**RE: Northern Beaches Link and Gore Hill Freeway Connection
Environmental Impact Statement (EIS)**

The Artarmon Progress Association (APA) welcomes the opportunity to provide comments on the Northern Beaches Link (NBL) – Gore Hill Freeway Connection (GHFC) Environmental Impact Statement (EIS). Given APA's remit is to promote the welfare, physical and intellectual advancement of the suburb of Artarmon our submission is focused on the Artarmon community.

Image 1 - Proposed Reserve Rd Works

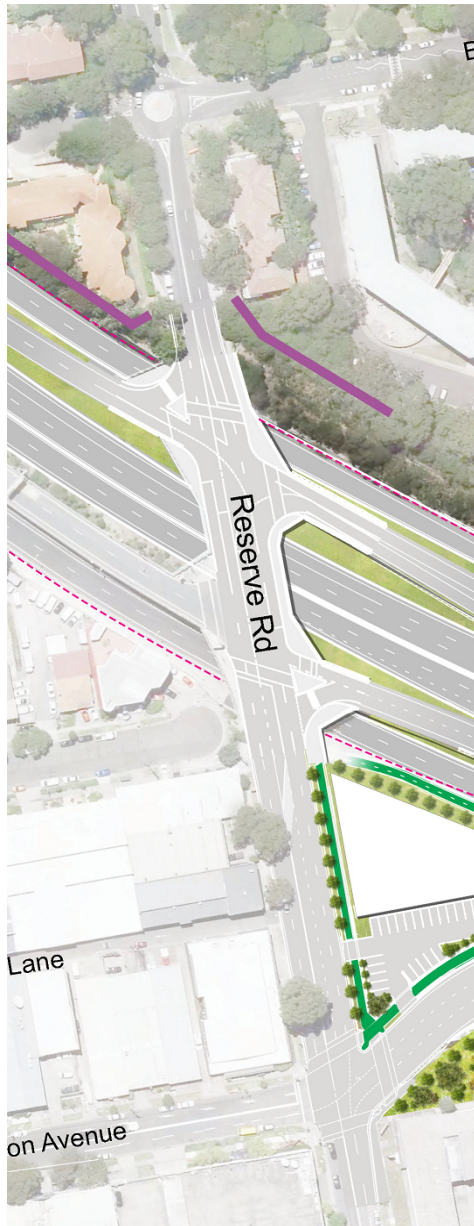
The project proposes an extra north-bound lane be added to the Reserve Rd bridge as shown in image 1 below.

It is not at all clear what the proposed lane configuration is, however APA believes the extra lane will allow a greater volume of traffic to turn onto the Gore Hill Freeway eastbound and onto the Beaches Link.

However, as indicated by the data for Reserve Rd / Barton Rd in the above table 1, southbound traffic in Reserve Rd would also benefit from an additional lane to reduce queuing at the Gore Hill Freeway intersection.

Image 2 - Concept: Diverging Diamond without addition of additional lane

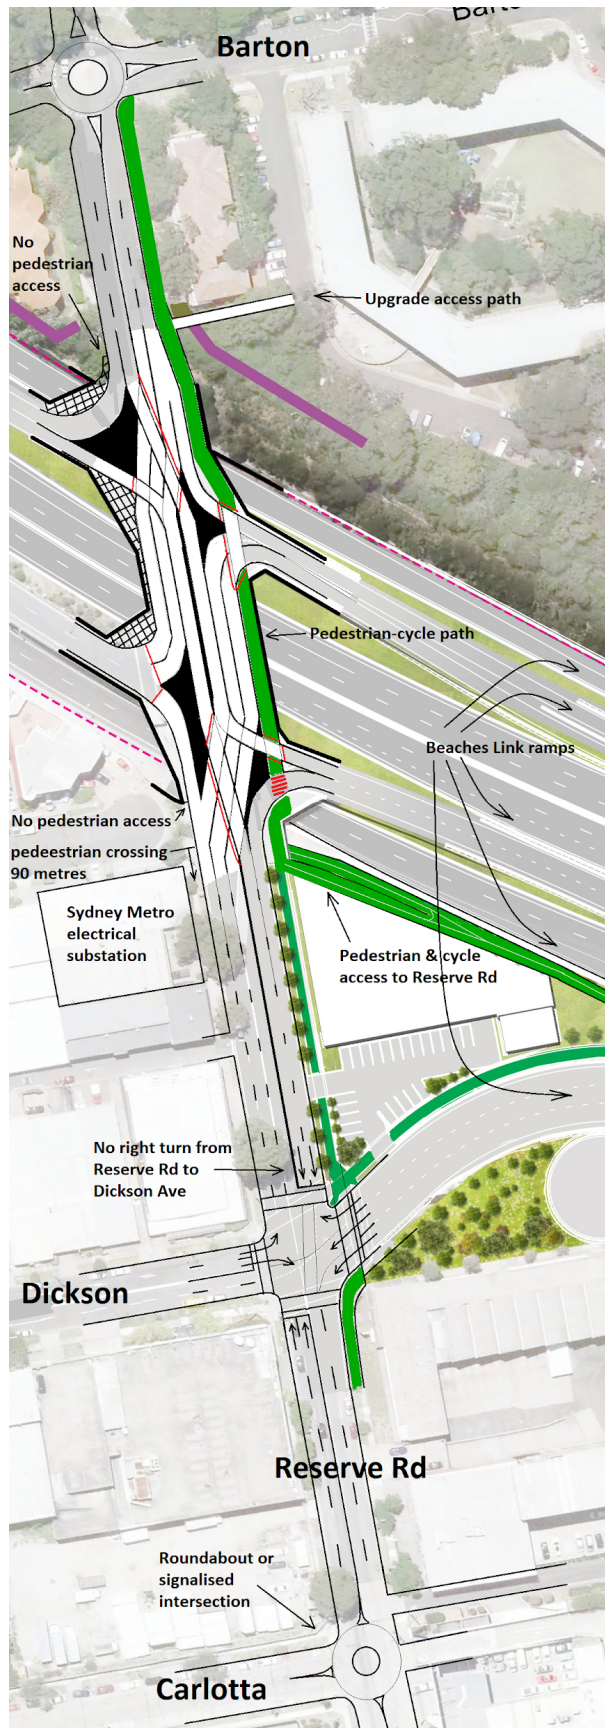
As shown in image 2, this concept is a reconfiguration of the existing intersection utilising a 'diverging diamond' to optimize the turning capacity from Reserve Rd onto the Gore Hill Freeway and Beaches Link from Reserve Rd onto the M2 and Longueville Rd. This option does not require the addition of an additional lane to the bridge so could be implemented immediately.

If performance of this intersection improved to the desired level, then it may be possible to avoid the need to add an additional lane as part of the project.

Image 5 - Concept: Bifurcation of the Beaches Link exit

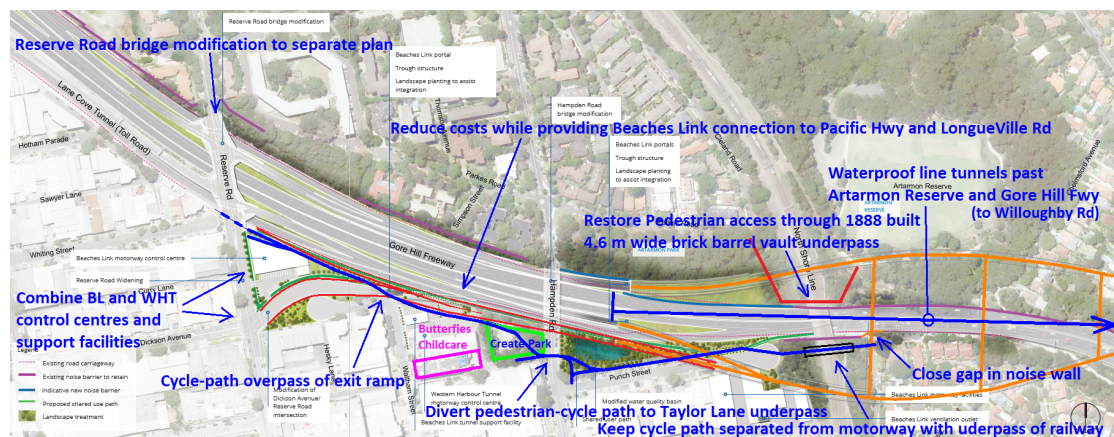
Add a branch to the proposed Beaches Link exit ramp to the Reserve Rd-Dickson Ave intersection, to provide a direct link to the Gore Hill Freeway's Pacific Hwy & Longueville Rd exit ramp.

As outlined in red in the image 5 below, this link is parallel to the Beaches Link connection to the Lane Cove Tunnel. It would allow traffic to access either Dickson Ave or the Pacific Hwy & Longueville Rd exit ramp.

To facilitate this link, the Tier 1 pedestrian-cycle path is directed along the Punch St alignment to pass under the Hampden-Herbert road at the Taylor Lane underpass.

This measure reduces the 'cut & cover' tunnel length and likely to reduce costs. In addition it will reduce the increase in traffic in Dickson Ave which was never intended as an arterial road and has some current issues such as the 'four stop-sign' intersection with Clarendon Street which will need to be resolved.

Image 6 - EIS Ground Water Levels

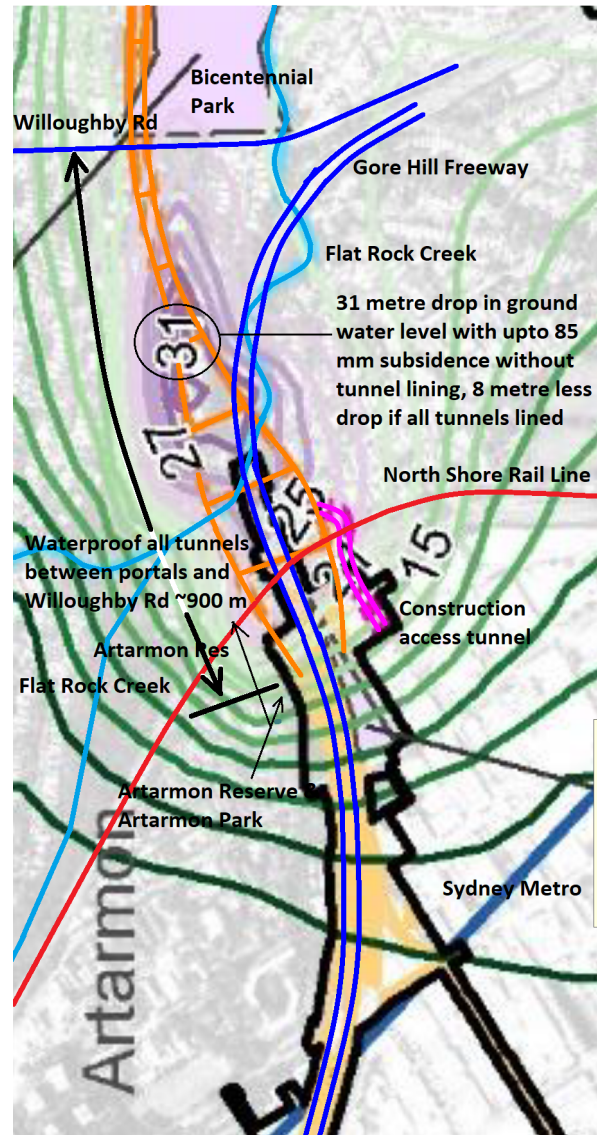
- 2.1. Image 6 to the right, extracted from the EIS, shows the depth of groundwater draining by the proposed motorway 100 years after completion. It is about 8 metres less at the end of construction. If the tunnels get a "waterproof" lining, the groundwater draining is reduced by 8 metres. The EIS suggests lining the tunnels for the first 300 metres from the portal, but APA believes that 900 metres of lining (to Willoughby Rd) are needed to minimise the groundwater draining from Artarmon Reserve, Chelmsford Ave and Richmond Ave and the Channel Nine site.
